## **DAWES OAK SUBDIVISION**

APPLICATION NUMBER 10 DATE November 2, 2006  
APPLICANT Dawes Oak Subdivision  
REQUEST Subdivision

# DETAIL SITE PLAN

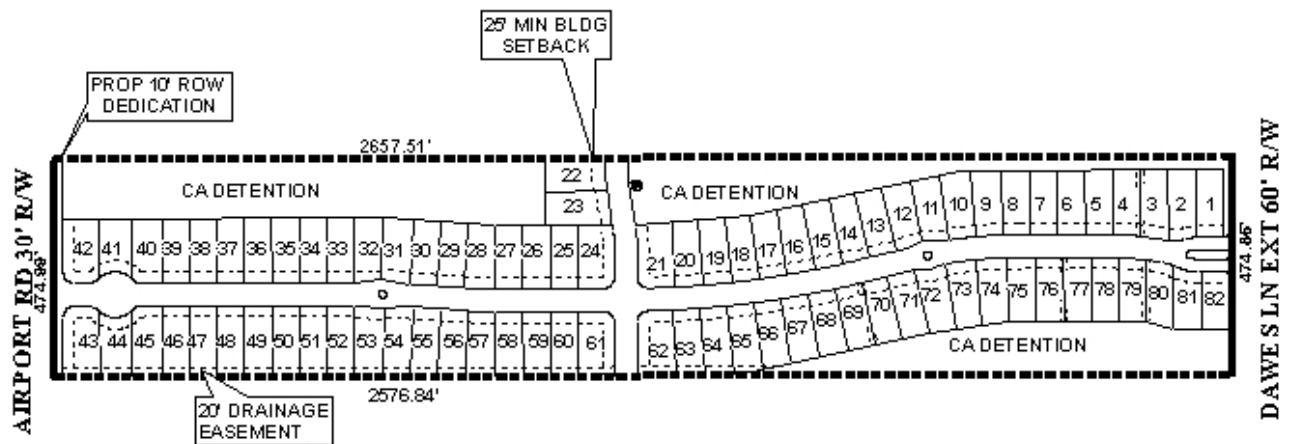
The site fronts Dawes Lane Extension, which has a 60-foot right-of-way, and Airport Road, a graded dirt road with a 30-foot right-of-way. Airport Road is illustrated on the Major Street plan with a 100-foot right-of-way; as such dedication sufficient to provide 50-feet from the centerline will be required (the preliminary plat appears to show sufficient dedication, but the dedication is labeled as 10-feet), as will 25-foot building setbacks along those frontages. Lots 42 and 43 should be denied direct access to Airport Road, while lots 1 and 82 should be denied direct access to Dawes Lane Extension. Furthermore, access to Airport Road for the entire subdivision should be denied until the road is improved to County Engineering standards.

The application involves the creation of new streets, street stubs, turnarounds, and traffic calming devices, which should be constructed and dedicated to County Engineering standards. The southern street stub should adjoin the Dawes Creek Subdivision street stub, as shown on the plat.

Detention and common areas are shown on the plat; these should be labeled and accompanied by a note on the final plat stating that their maintenance will be property owners' responsibility.

The plat has a label stating that the minimum lot size is 7,500 square feet, and that the actual smallest lot size depicted is 8,400 square feet; proposed lot 79 is labeled as being 8,183 square feet.

It should also be pointed out that the proposed lots 1 and 82 are less than 25 feet from the right-of-way edge of Dawes Lane Extension, thus a setback line should be required along the street side of these two lots to provide the equivalent of a 25-foot setback from the Dawes Lane Extension right-of-way.

The plat meets the minimum requirements of the Subdivision Regulations and is recommended for Tentative Approval, subject to the following conditions: 1) the dedication of right-of-way sufficient to provide 50-feet from the centerline of Airport Road; 2) the illustration of the 25-foot building setbacks from all streets, including the planned major street right-of-way dedication, and provision of a side yard setback for proposed Lots 1 and 82 to provide the equivalent of a 25-foot setback from the right-of-way edge of Dawes Lane Extension; 3) the placement of a note on the final plat stating that the site is denied access to Airport Road until it is constructed to County standards; 4) the placement of a note on the final plat stating that Lots 42 and 43 are denied direct access to Airport Road, and that Lots 1 and 82 are denied direct access to Dawes Lane Extension; 5) the construction of the new streets and traffic calming devices to County Engineering standards; 6) the connection of the southern street stub to the Dawes Creek stub, as shown on the plat; 7) the placement of a note on the final plat stating that maintenance of common and detention areas will be property owners' responsibility; 8) verification of the minimum and maximum lots sizes within the subdivision, and revision of the lot size notes on the plat if necessary; 9) provision of a certification letter from a licensed engineer to the Planning Section of Urban Development, certifying that the stormwater detention, drainage facilities, and release rate comply with the City of Mobile stormwater and flood control ordinances, prior to the signing and recording of the final plat; and 10) the placement of a note on the final plat stating that any lots that are developed commercially and adjoin residentially developed property must provide a buffer, in compliance with Section V.A.7 of the Subdivision Regulations.
